CITY OF ALBUQUERQUE

Re: 1st Nations Community Health Source
5608 Zuni RD SE
Traffic Circulation Layout
Engineer's/Architect's Stamp XX-XX-XX (L18-D047)

Based upon the information provided in your submittal received 12-09-16, the above referenced plan cannot be approved for Building Permit until the following comments are addressed:

AS-101

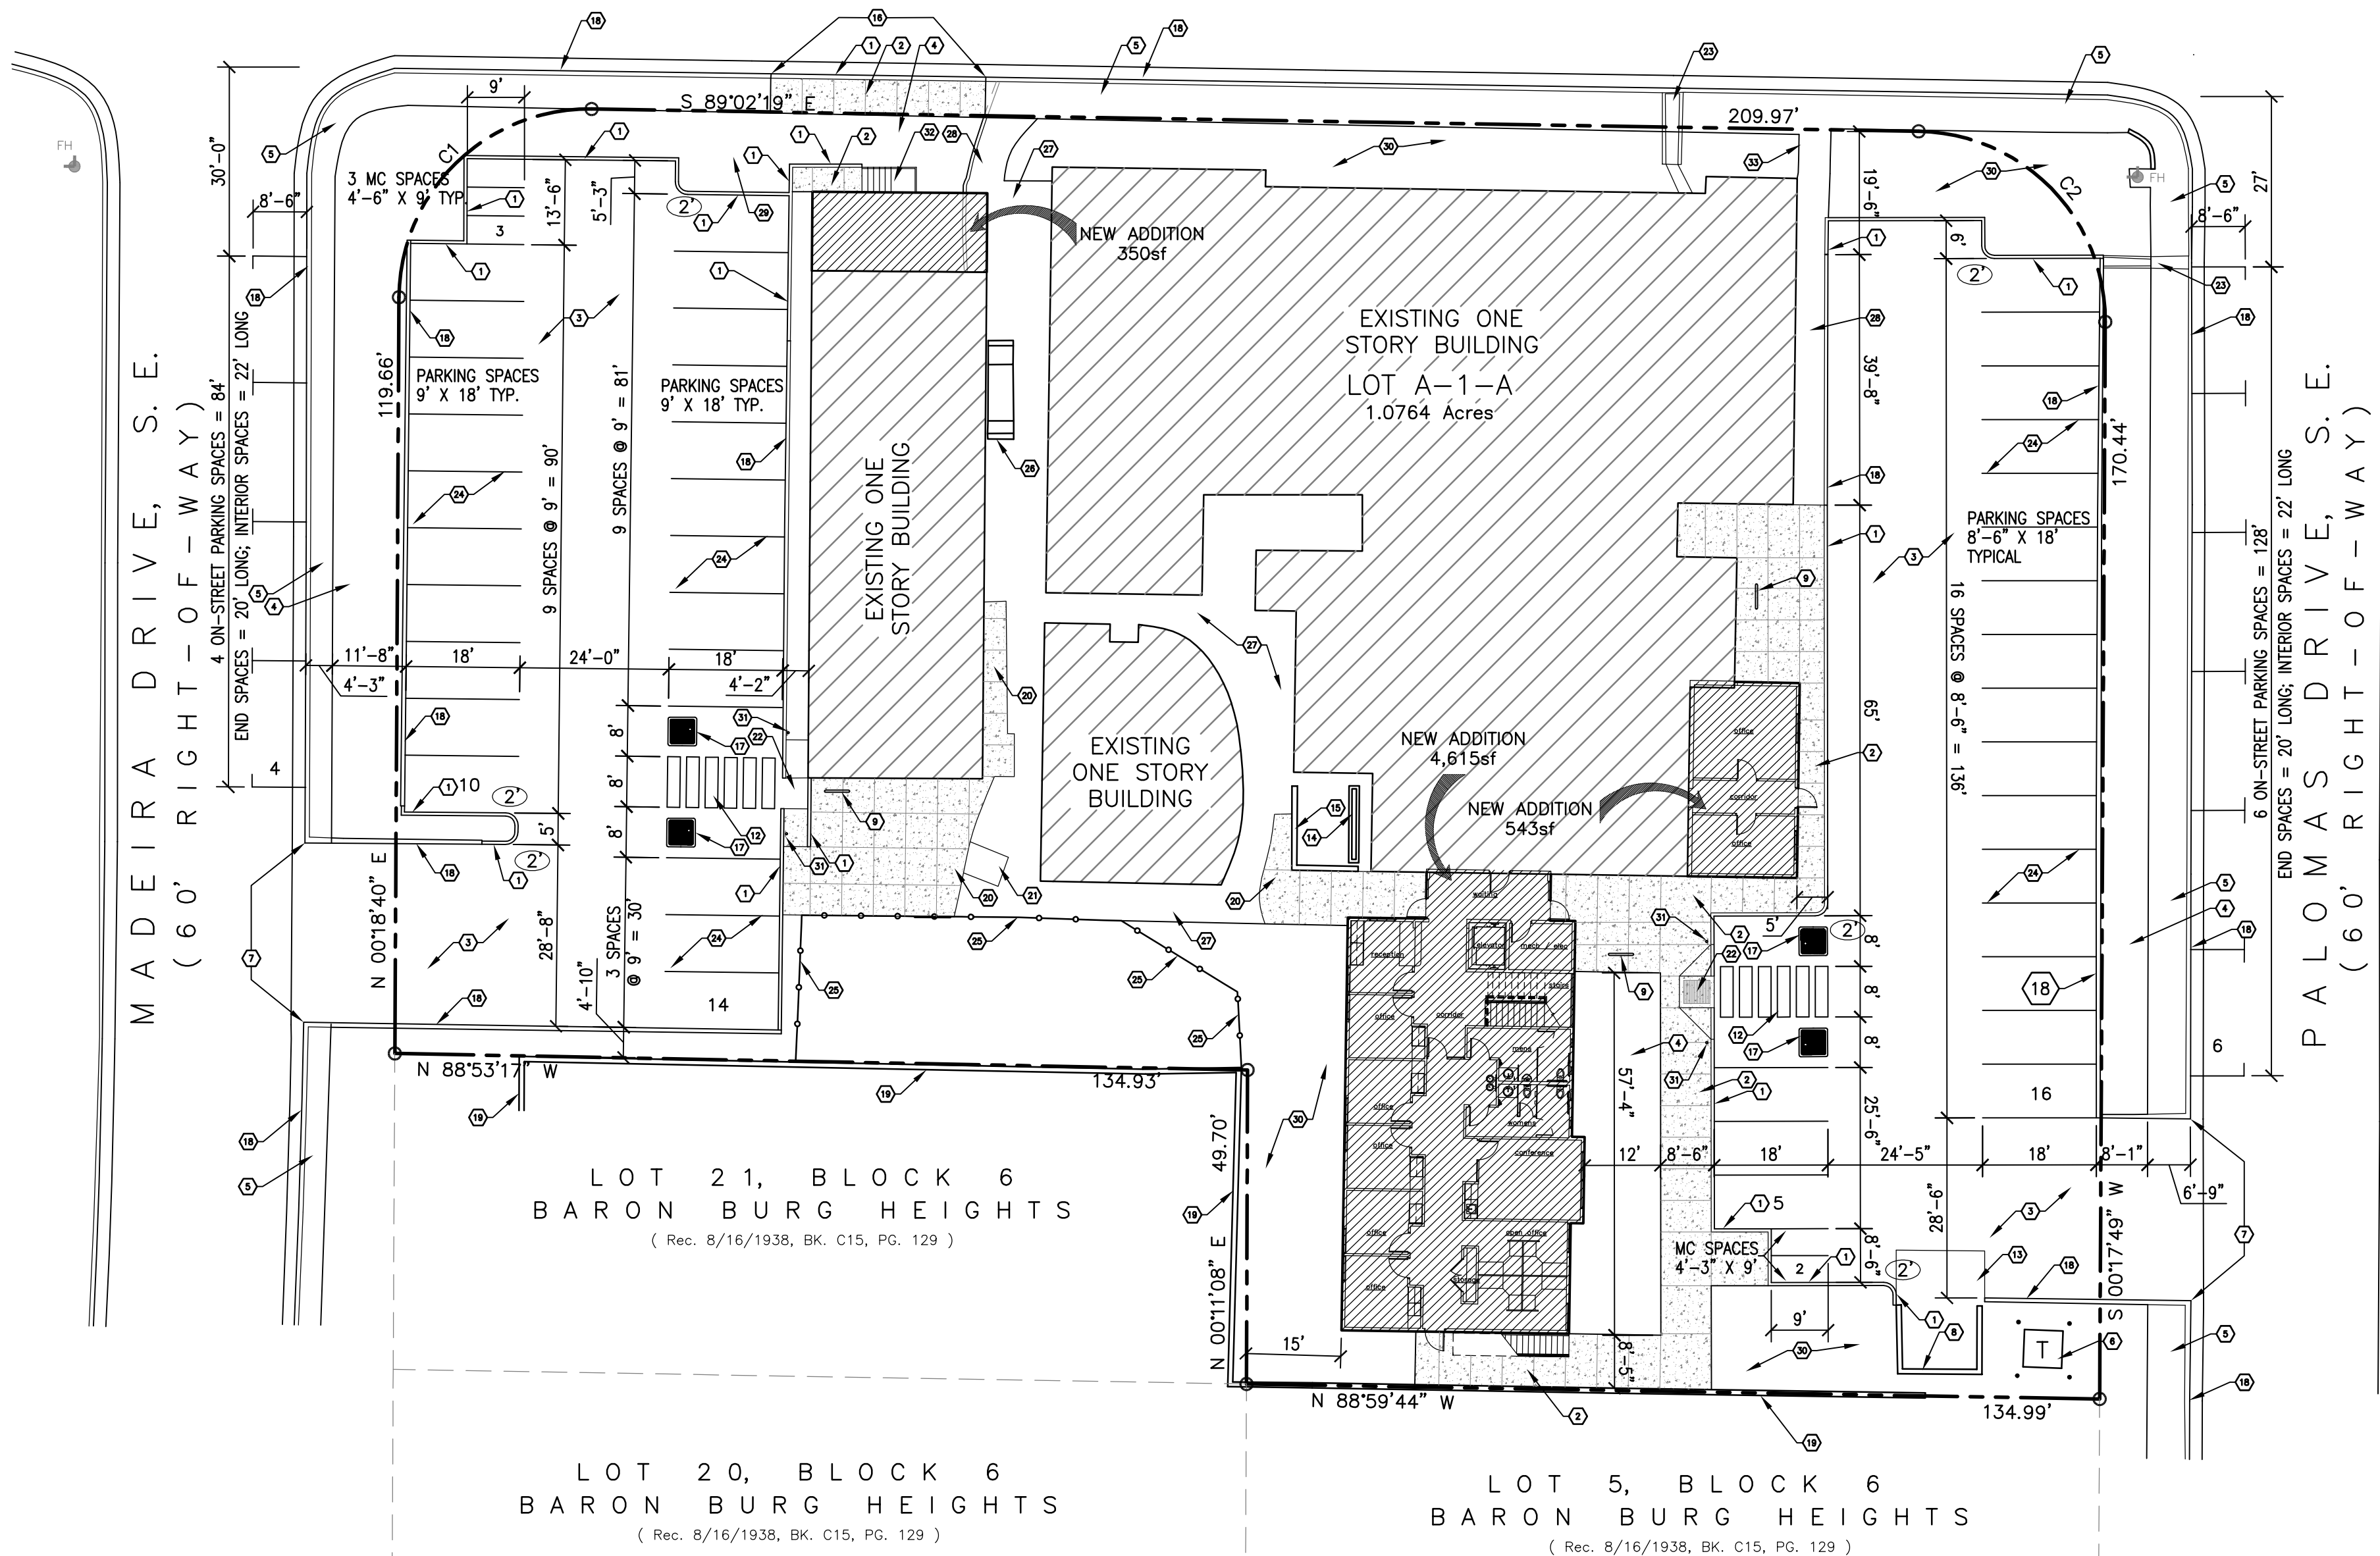
1. The traffic circulation layout must be stamped, signed, and dated by an engineer or architect licensed in the state of New Mexico.
2. The ADA accessible parking sign must have the required language per 66-7-352.4C NMSA 1978 **"Violators Are Subject to a Fine and/or Towing."** Please call out detail and location of HC signs.

3. The ADA access aisles shall have the words **"NO PARKING"** in capital letters, each of which shall be at least one foot high and at least two inches wide, placed at the rear of the parking space so as to be close to where an adjacent vehicle's rear tire would be placed. (66-1-4.1.B NMSA 1978)

4. The ADA parking space has a clearly visible, blue, International Symbol of Accessibility painted on the pavement at rear of the space (66-1-4.1.E NMSA 1978) or MUTCD recommends a white symbol on a blue background.

5. Please specify the City Standard Drawing Number when applicable. Use Standard curb and gutter 2415A to close the driveway.
6. On-Street parking credit to fulfill zoning's parking requirement must be requested and approved by the Traffic Engineer, Racquel Michel prior to TCL approval. The application requires at least 45 working days. On-street parking credit is based on available parking along public right-of-ways fronting the property. The business will only be granted 50% credit for available street parking.

7. Please include two copies of the traffic circulation layout at the next submittal.
